NOTICE AND AGENDA
Regular Meeting
Idaho Springs Planning Commission
1711 Miner Street, City Hall
Wednesday, April 12, 2023 – 6:00

TO: Planning Commission
CC: City Administrator Andrew Marsh
FROM: Jonathan Cain, Assistant City Administrator &
Interim Community Development Planner
DATE: April 12, 2023
SUBJECT: Proposed Final Development Plan for 1620 Colorado Blvd.
ATTACHMENTS: Submission Materials

Igadi, Ltd. (the “Applicant”), and Pennell & Associates, (the “Property Owner”) request approval of a Final Development Plan (FDP) at 2820 Colorado Boulevard (the “Property”) for the construction of a Marijuana Cultivation Facility (the “Project”). This building will be located adjacent to the existing Igadi Retail Dispensary at 2818 Colorado Boulevard.

Project: Igadi Ltd. Cultivation Facility Final Development Plan

Sheet Description
EXTERIOR
VIEWS

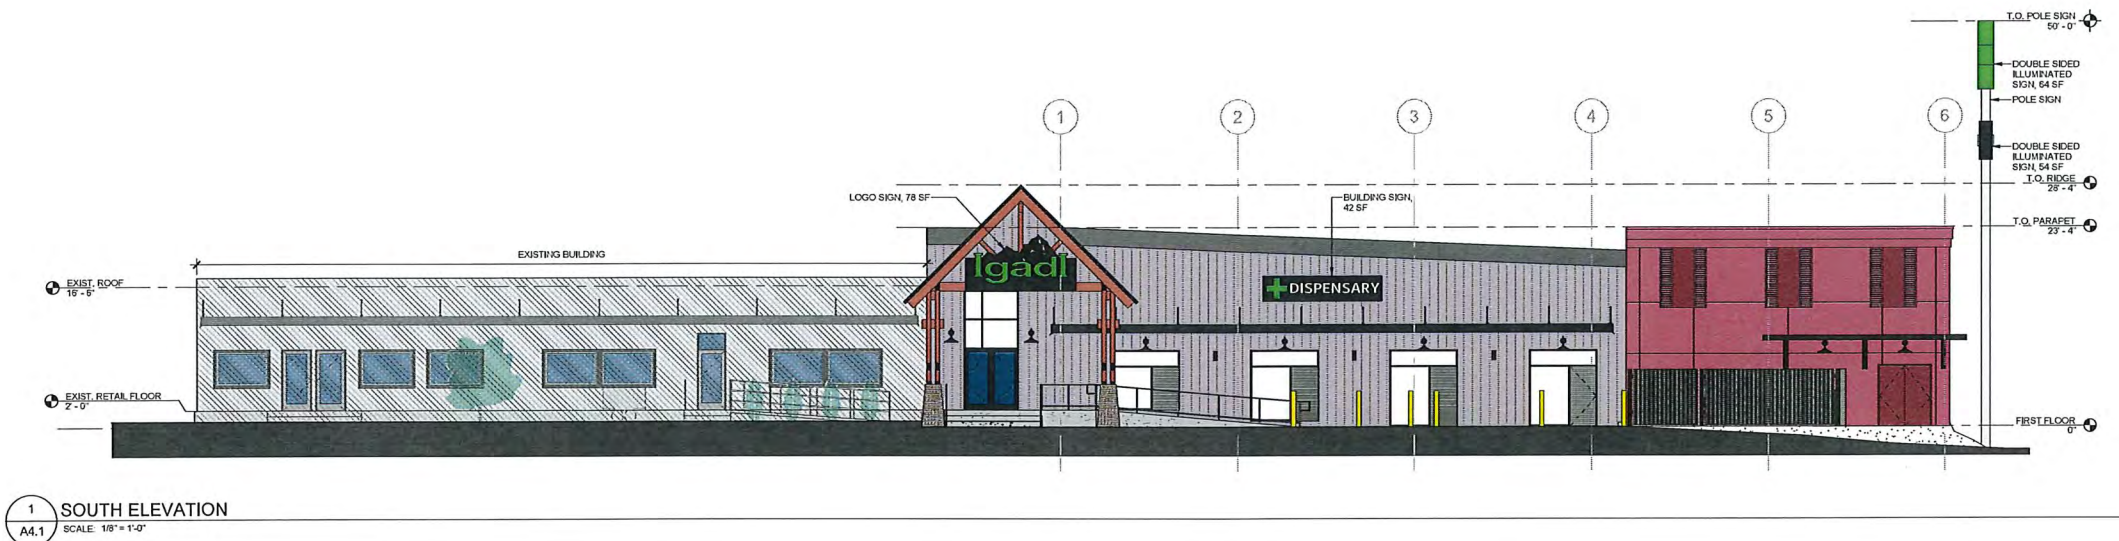
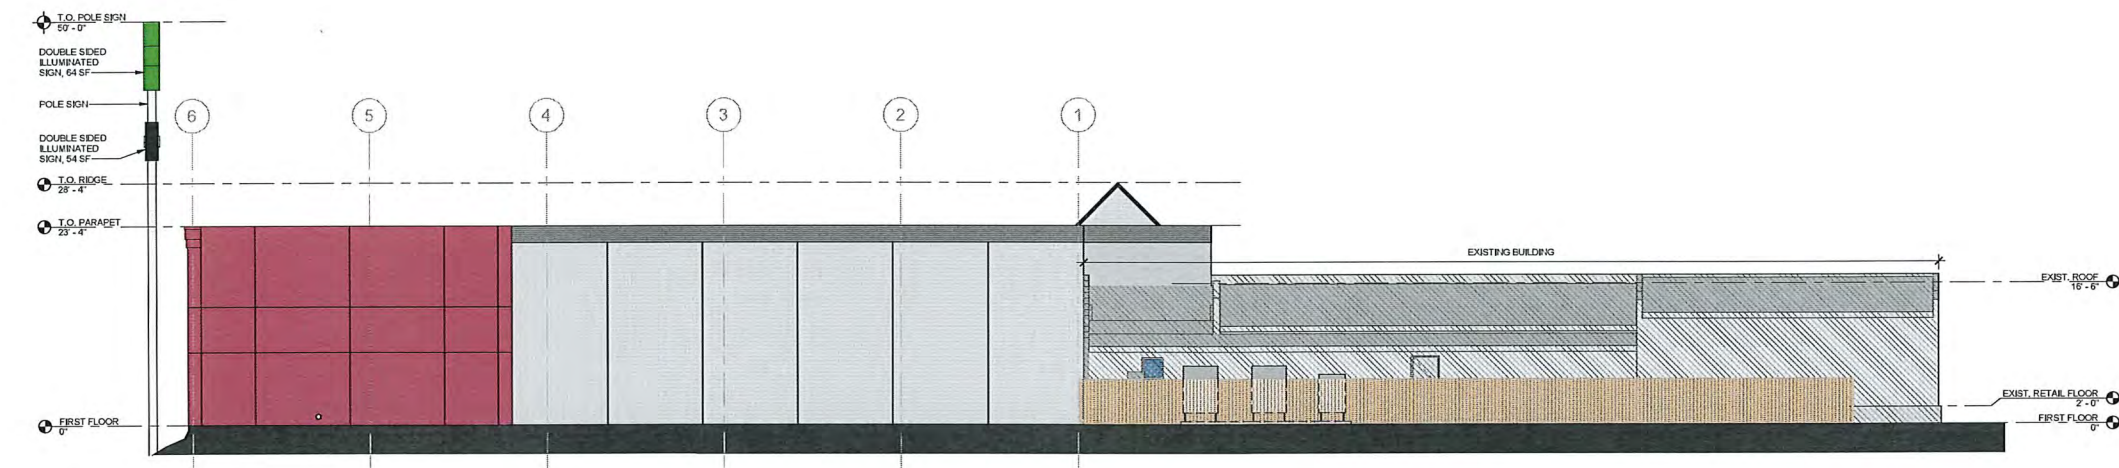
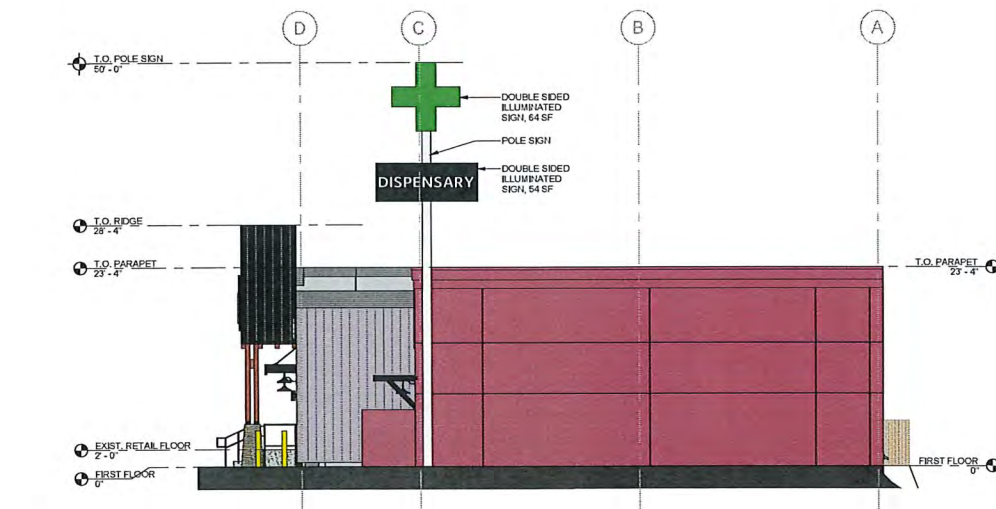
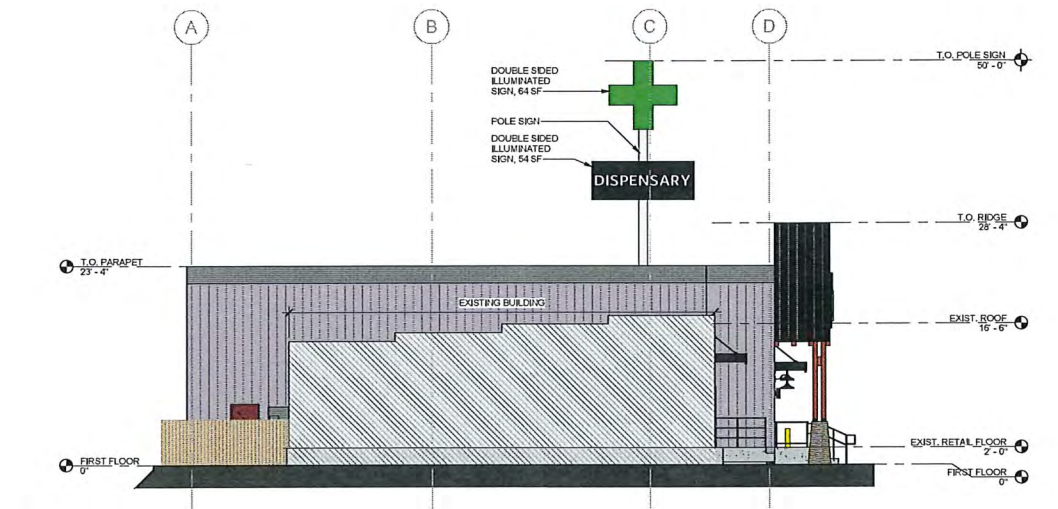
Analysis: The proposed building will be clad in pre-finished metal panels. The side of the building will be clad in stucco-colored panels, and the front of the building will be clad in corrugated steel-colored panels. **The proposed exterior materials appear to be on the list of prohibited materials listed in the General Standards of the East End Overlay District.** The Applicant has been notified of this situation and asked to present possible alternatives to the Planning Commission.

1 SITE PLAN
SP1.1 SCALE: 3/32" = 1'-0"

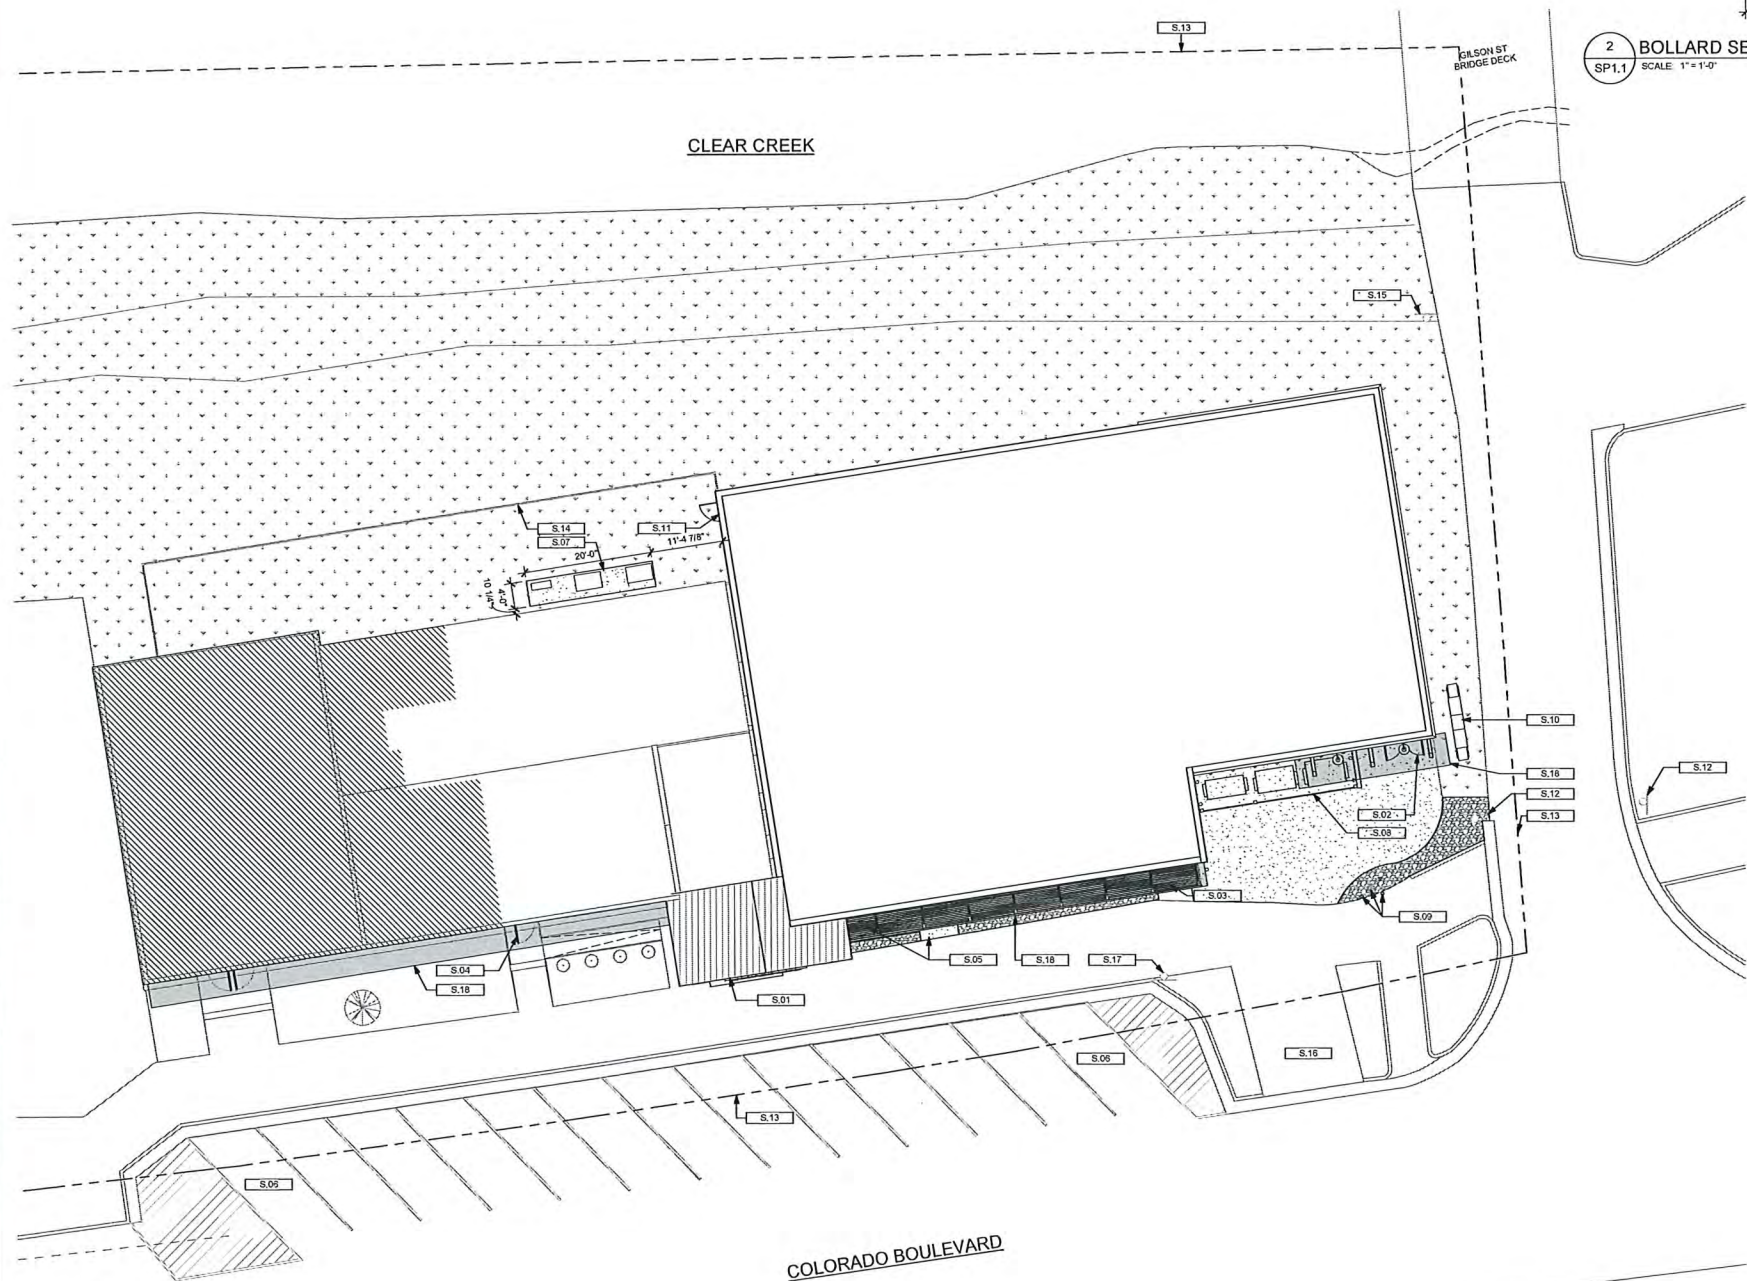
Analysis: There is currently no sidewalk connection on the East Side of this property along Gilson Street between the Bridge over Clear Creek to the north and to Colorado Boulevard to the south. Additionally, the current property line to the east extends into Gilson Street. **The provision of a sidewalk is required by the East End Action Plan.**

The current site plan shows a four-foot easement on the East End of the Property; per the agreement with the City a sidewalk and site grading plan must be shown on the site plan wide enough to accommodate the construction of the sidewalk without impacting the foundation of the new building. Additionally, the Applicant must provide the property for the sidewalk to the City through Easement or some other means. **These are conditions of approval for this FDP.**

Properties located in Sign Zone 1 are allowed to have 1 pole sign per premises. Pole Signs must have a 10 ft. Setback. **The Pole Sign identified in the Site Plan does not meet this setback requirement.**

- a) Roof Drains are shown; however, it is unclear where they discharge. Show on Civil Site Plan and include downspout or discharge direction and erosion control measures to protect slope from erosion.
- b) A sidewalk along Gilson Street should be shown on the Civil Site Plan per the agreement with the City.
- c) ADA ramp and connections to sidewalk on Colorado Boulevard on Civil Site Plan should be shown with proposed grades to match existing.
- d) Provide slope arrows on Site Plan to show direction of slope around site.

On April 5, 2023, the Applicant submitted an updated site plan that appears to satisfy some of these requirements. JVA Engineering analyzed this Site Plan and determined that all conditions except for (b) were met. **A Sidewalk and site grading plan for the same that meet the standards and specifications for Design and Construction and are approved by the City Engineer must be provided on the Site Plan as a condition of approval for this project. An Easement or Vacation of Property accommodating the same must be provided to the City as a condition of approval for this project.**

1. Prior to the issuance of any permit related to the Plan, the following shall occur:
 - a. An amended Site Plan must be filed with and approved by the City Administrator that includes Sidewalk and Grading details along the east side of Gilson Street from Colorado Boulevard to the Gilson Street Bridge that conform to the design specifications of the City of Idaho Springs.
 - b. The property owner shall provide approximately 10 feet width of right of way dedication approved by the City-- either by easement or by a subsequent plat amendment—on the east side of the property between the Gilson Street Bridge and Colorado Boulevard deemed adequate for the maintenance and upkeep of Gilson Street and the installation of a new sidewalk.
 - c. The proposed Pole Sign shall be relocated to meet the 10-foot setback requirement.
